# Access Compliance Report

## Public Rights-of-Way

### (Curb Ramps)

Intersection ID: 30613	Main Street: GOLF_LINKS_DR	Cross Street: PROVIDENCE_RD	Location: SW
ADA ID: EDEC2578FBAA	Ramp Type: Perp	Initial Pass/Fail: Fail	Overall Compliance: No
Severity Score: 13.75			
Codes/Mitigation Info/Possible Solution		Field Measurements/Component Compliance

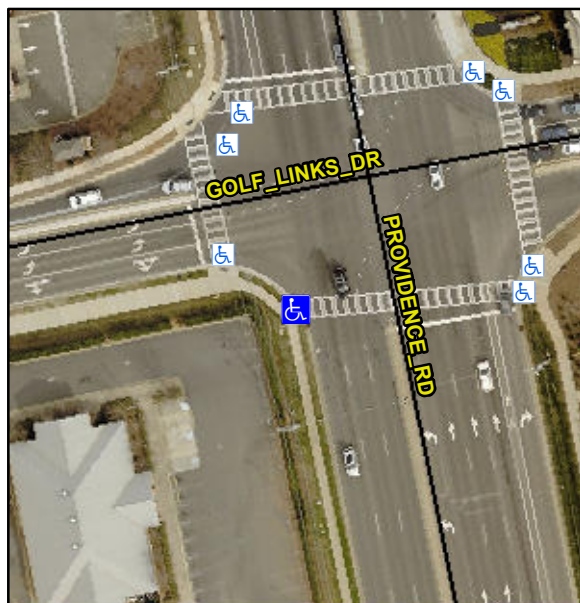
**Not Found, R304.2.2, R304.5.3**

Compliance	Description	Data	Compliance	Description	Data
N/A	Ramp Length (in)	47.0	No	Ramp Slope (%)	9.6
Yes	Ramp Width (in)	59.0	No	Ramp XSlope (%)	4.1
N/A	Flare Type LT	N/A	N/A	Flare Type RT	N/A
N/A	Flare Slope LT (%)	N/A	N/A	Flare Slope RT (%)	N/A
N/A	Flare Traversable LT?	N/A	N/A	Flare Traversable RT?	N/A
N/A	Landing Length (in)	N/A	N/A	DWS Provided?	N/A
N/A	Landing Width (in)	N/A	N/A	DWS Contrast?	N/A
N/A	Landing Slope (%)	N/A	N/A	DWS Length (in)	N/A
N/A	Landing X Slope (%)	N/A	N/A	DWS Full Width?	N/A
N/A	Landing Curb? (Y/N)	N/A	N/A	DWS Offset (in)	N/A
N/A	Shared Landing?	N/A			
N/A	Gutter Ponding?	Yes	N/A	Gutter Slope (%)	N/A
N/A	Gutter Lip Ht (in)	2.0	N/A	Gutter X Slope (%)	N/A
N/A	Painted X Walk1?	Yes	N/A	Painted X Walk2?	N/A
	X Walk 1 Direction	To E		X Walk 2 Direction	N/A
N/A	X Walk 1 Width (in)	104.0	N/A	X Walk 2 Width (in)	N/A
	X Walk 1 Slope (%)	3.4		X Walk 2 Slope (%)	N/A
	X Walk 1 X Slope (%)	3.8		X Walk 2 X Slope (%)	N/A

**Remove & Replace Entire Ramp.**
